Docket Item # 2 & 3
BAR CASE # 2014-0378 &
2014-0379

BAR Meeting
March 18, 2015

ISSUE: Partial Demolition/Capsulation and Addition

LOCATION: 214 South Alfred Street

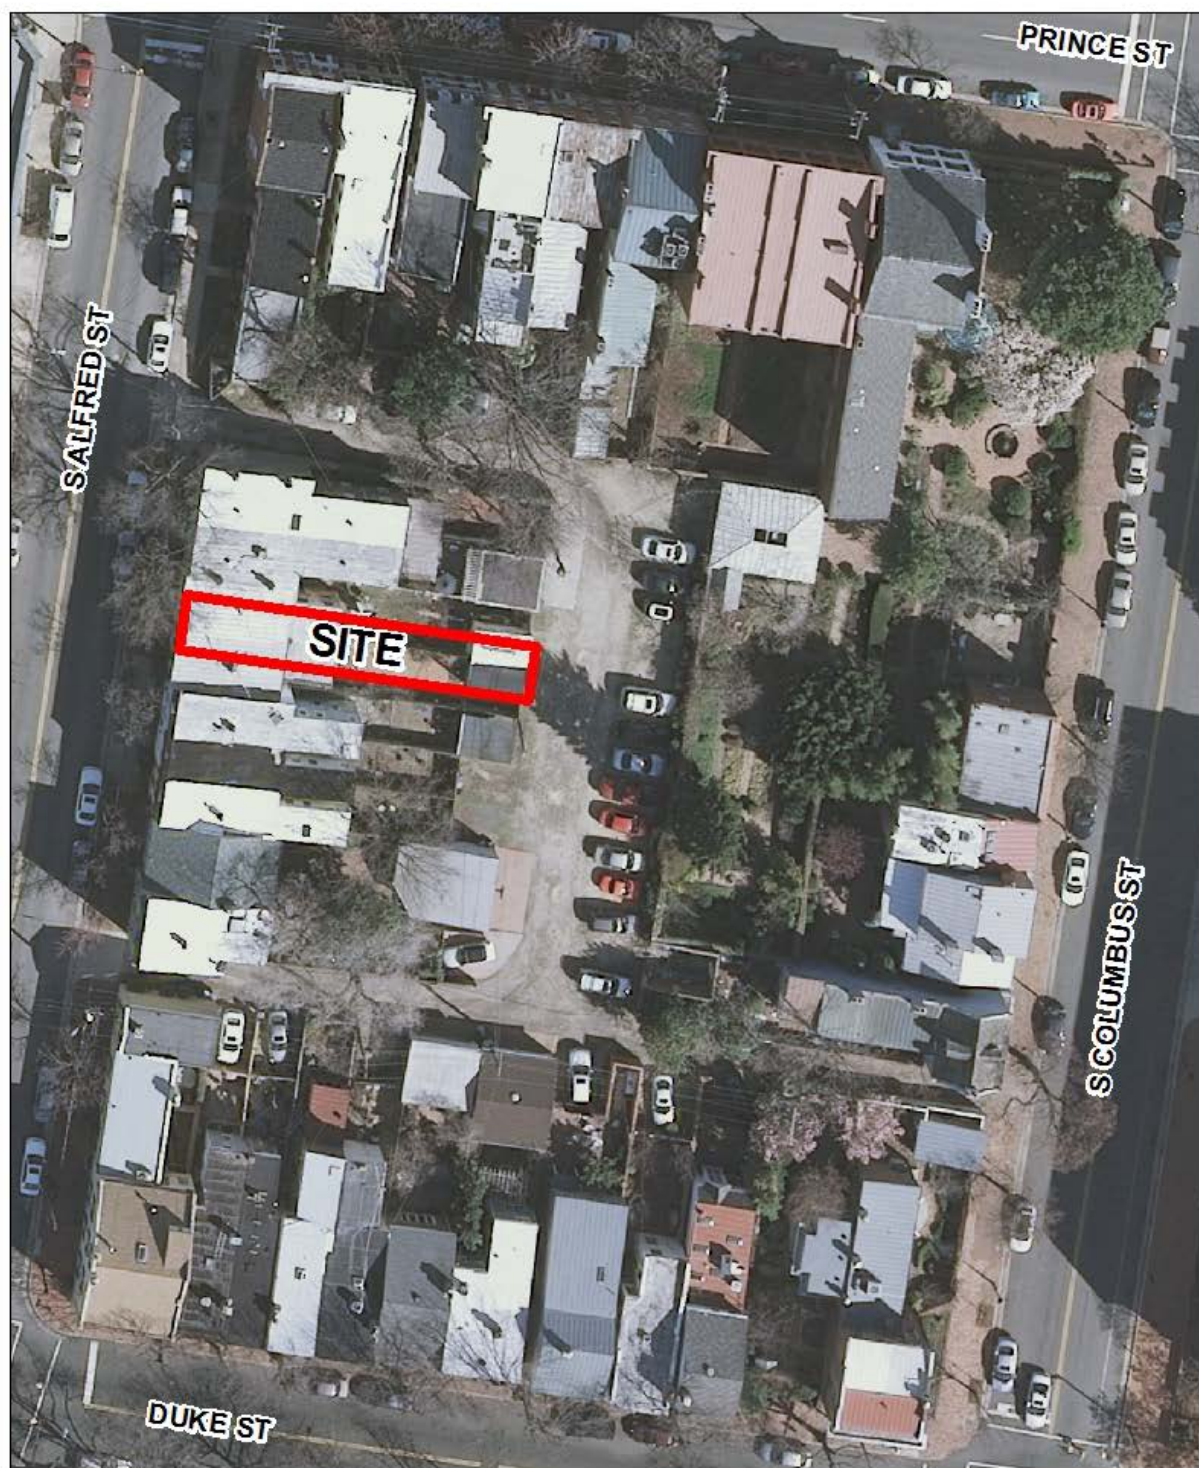
Staff recommends deferral of the Permit to Demolish/Capsulate and Certificate of Appropriateness for restudy of an alternative that:

1. At a minimum, the south wall and significant portions of the roof of the ell be retained, and;
2. The main block, ell, and proposed addition read as three distinct components to illustrate the evolution of the property.
